ARMY ENGINEER DISTRICT ST LOUIS MO
NATIONAL DAM SAFETY PROGRAM. SNOW HOLLOW DAM (MO 30337). MISSIS--ETC(U)
SEP 78 R J DIECKMANN, K ALEXANDER

SNOW HOLLOW DAM
IRON COUNTY, MISSOURI

MISSOURI INVENTORY NO. 30337

PHASE I INSPECTION REPORT
NATIONAL DAM SAFETY PROGRAM

SNOW HOLLOW
LAKE
VICINITY TOPOGRAPHY
PLATE I

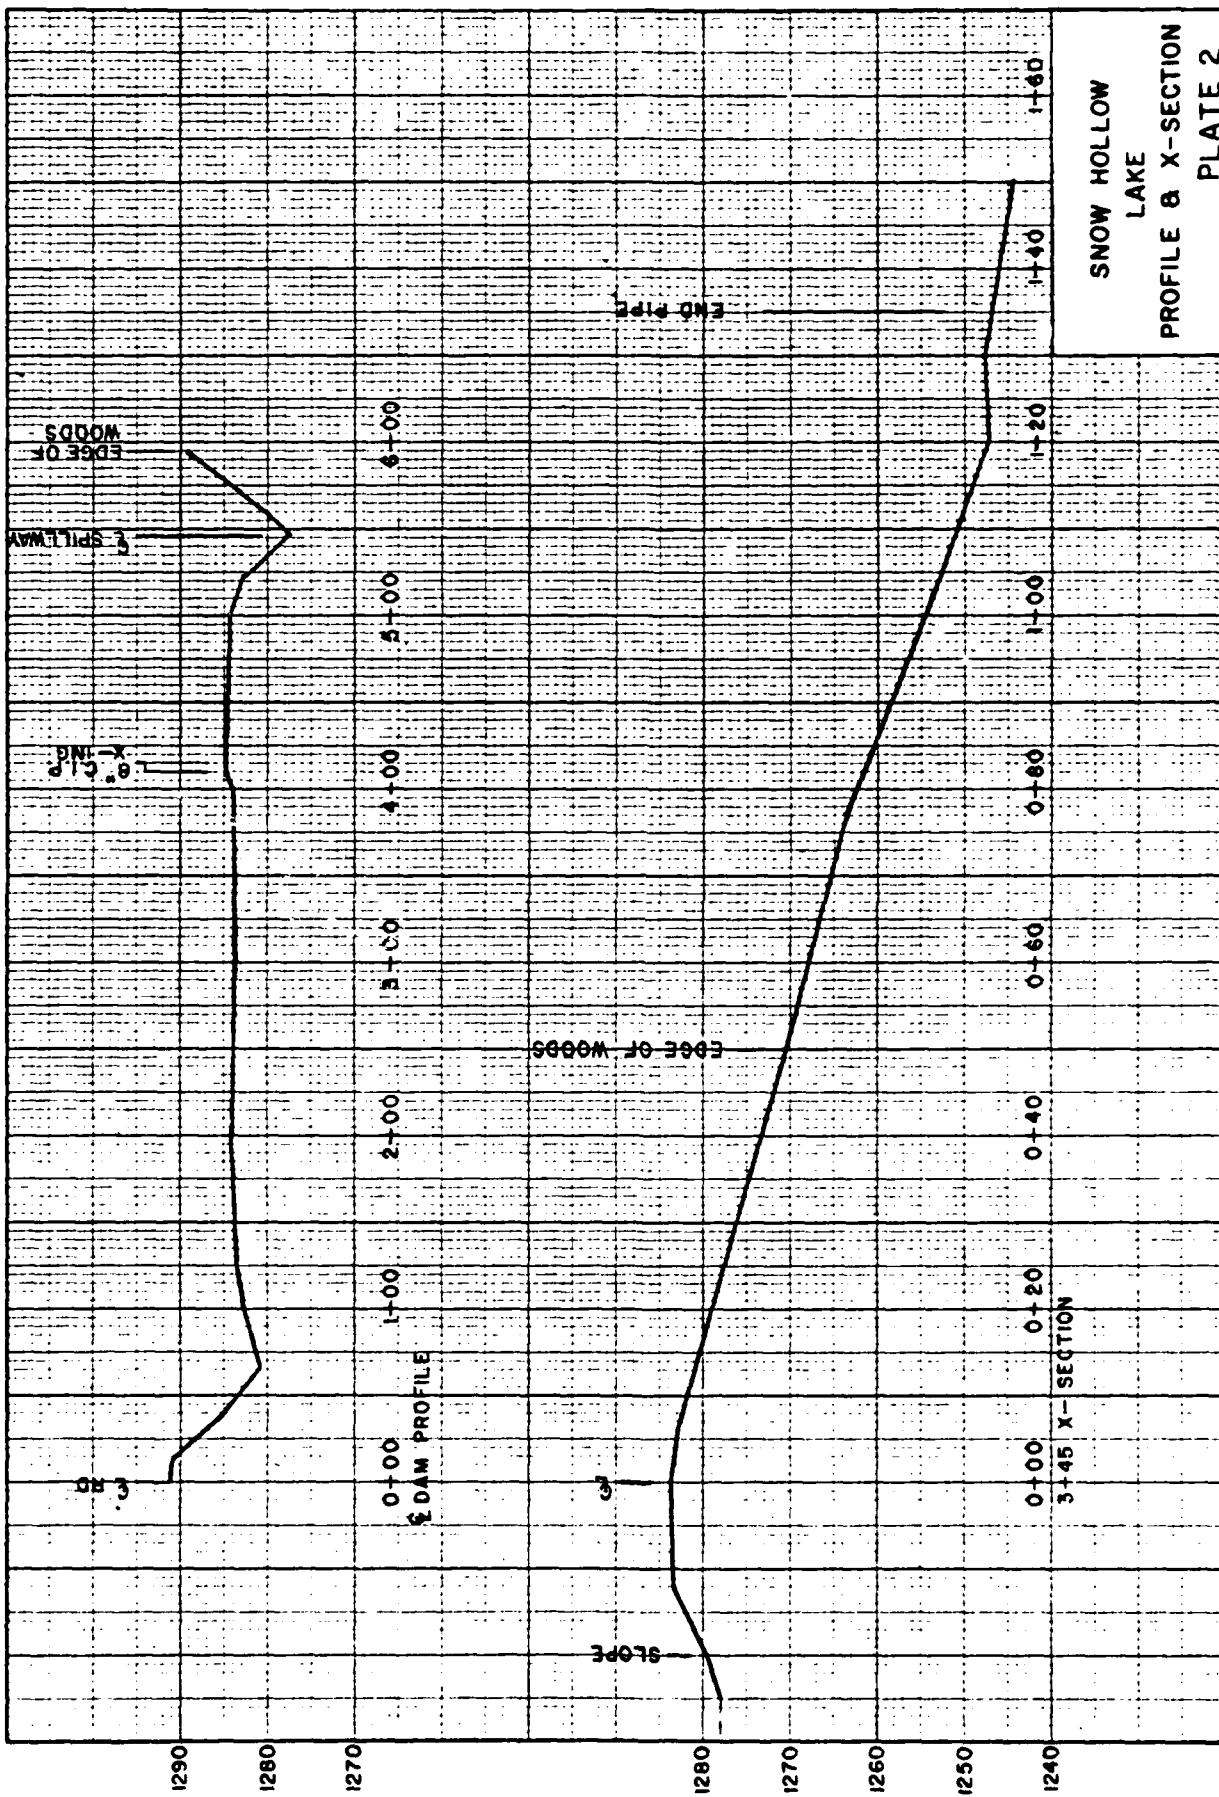
b. Location: The dam is located in the northeast portion of Iron County, Missouri. The general location of Snow Hollow Dam and the hilly topography in the vicinity of the lake are shown on PLATE 1. The lake is shown on the Graniteville, Missouri, quadrangle sheet in Sections 26 and 27, Township 34 north, Range 3 east of the fifth principal meridian.
